SAM D09 Series Family Silicon Errata and Data Sheet Clarification

Data Sheet Clarifications

The following typographic corrections and clarifications are to be noted for the latest version of the Device Data Sheet (Atmel-42414G-SAM-D09-Datasheet_09/2016).

FIGURE 30-3: BOD33 HYSTERESIS OFF

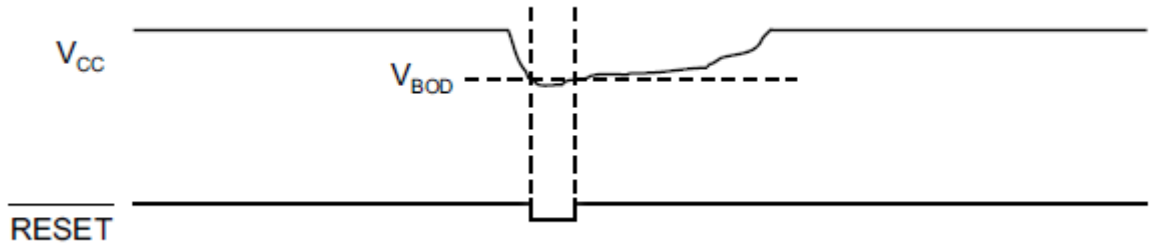
4. Module: Brown-out Detectors (BOD) Characteristics

Figure 30-3 and Figure 30-4 have an incorrect reset Polarity value. The corrected figures are as shown below:
